Access Compliance Report Public Rights-of-Way (Curb Ramps)

Intersection ID: 11698 Main Street: S_CEDAR_ST Cross Street: W_4TH_ST Location: N

ADA ID: BC2805292CC6 Ramp Type: PerpDiag Initial Pass/Fail: Pass Overall Compliance: No Severity Score:

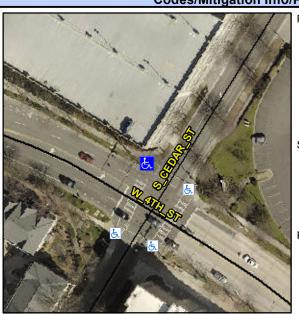
Remove & Replace Curb Ramp With Two New Directional Ramps or Equivalent.

R304.2.2-Perp, R304.3.2-Para,

R305.2
